JOSEPH M. FARLEY NUCLEAR PLANT, UNIT 2

AMENDMENT TO FACILITY OPERATING LICENSE

Amendment No. 81
License No. NPF-8

ATTACHMENT TO LICENSE AMENDMENT NO. 81

Figure 3.4-2 Farley Unit 2 Reactor Coolant System Heatup Limitations Applicable for the First 14 EFPY.

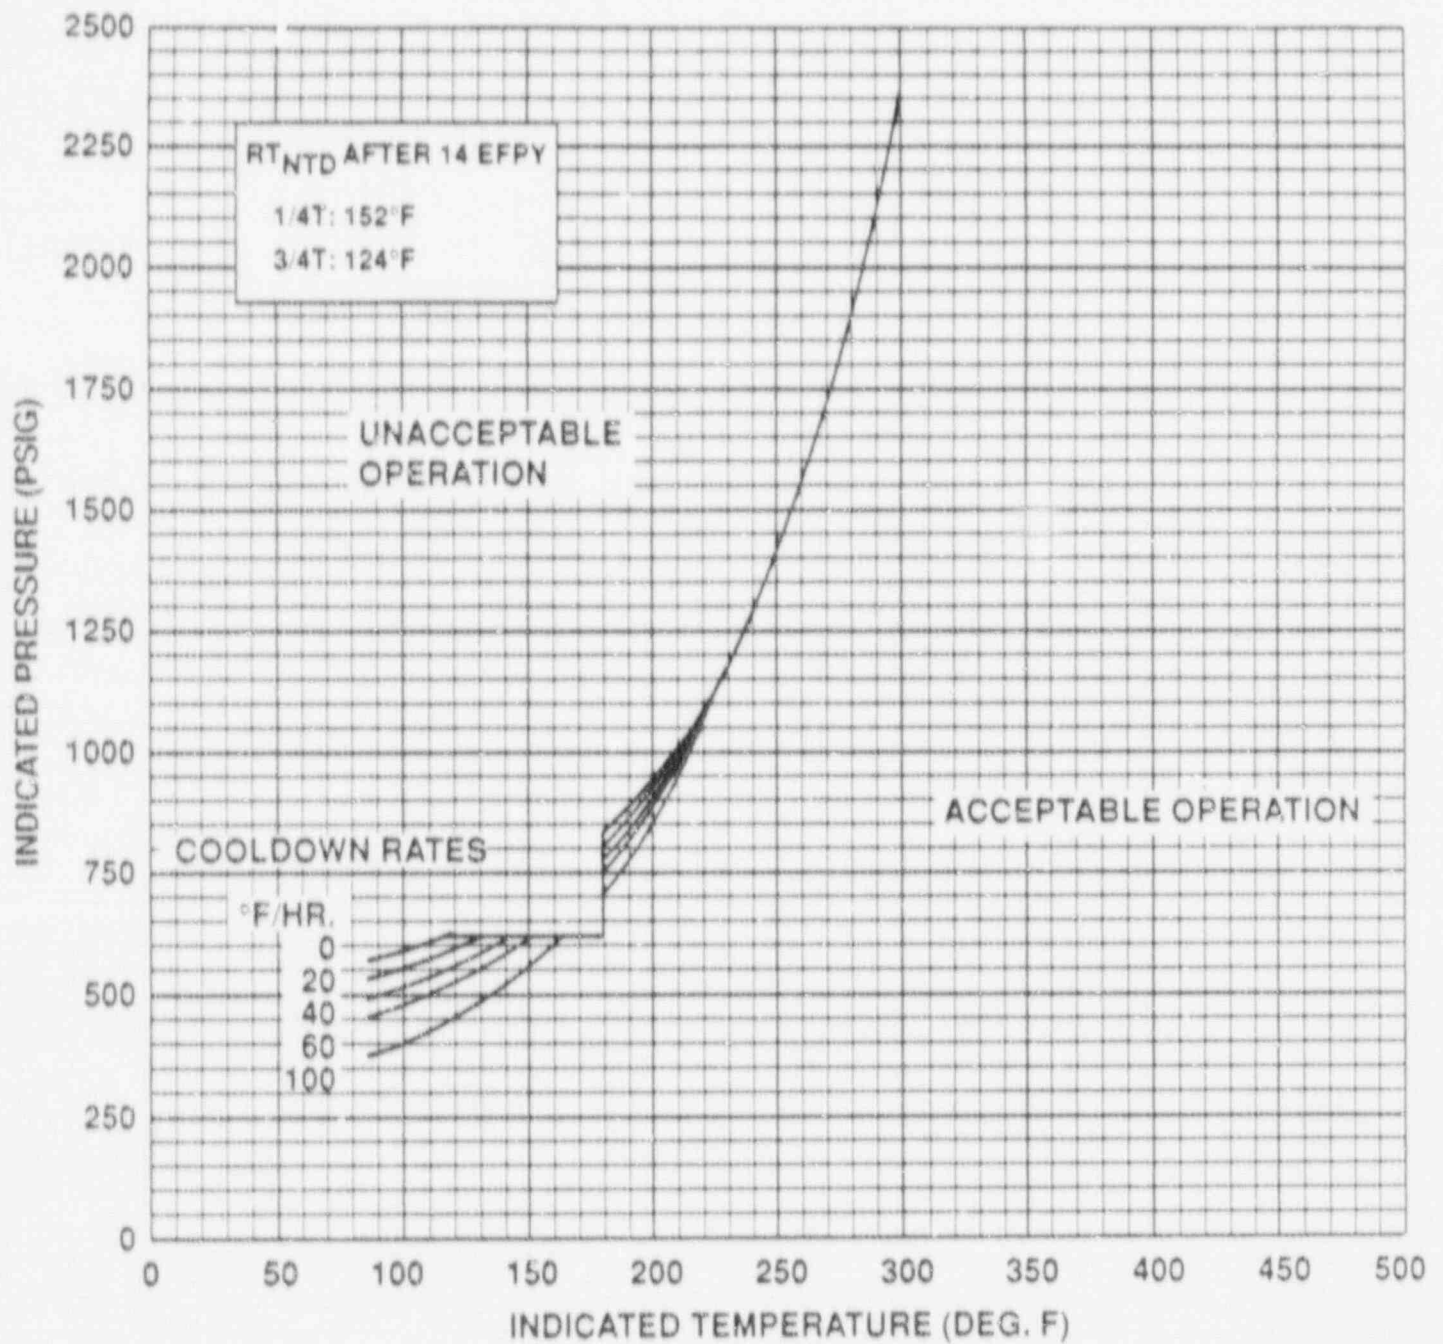
Replace the following pages of the Appendix A Technical Specifications with the enclosed pages. The revised areas are indicated by marginal lines.

Heatup and cooldown limit curves are calculated using the most limiting value of the nil-ductility reference temperature, RT_{ndt} , at the end of 14 effective full power years (EFPY) of service life. The 14 EFPY service life period is chosen such that the limiting RT_{ndt} at the 1/4T location in the core region is greater than the RT_{ndt} of the limiting unirradiated material. The selection of such a limiting RT_{ndt} assures that all components in the Reactor Coolant System will be operated conservatively in accordance with applicable Code requirements.

The reactor vessel materials have been tested to determine their initial RT_{ndt} ; the results of these tests are shown in Table B 3/4.4-1. Reactor operation and resultant fast neutron (E greater than 1 MEV) irradiation can cause an increase in the RT_{ndt} . Therefore, an adjusted reference temperature, based upon the fluence and the nickel and copper content of the material in question, can be predicted using WCAP-12471 and the recommendations of Regulatory Guide 1.99, Revision 2, "Radiation Embrittlement of Reactor Vessel Materials." The heatup and cooldown limit curves of Figures 3.4-2 and 3.4-3 include predicted adjustments for this shift in RT_{ndt} at the end of 14 EFPY.
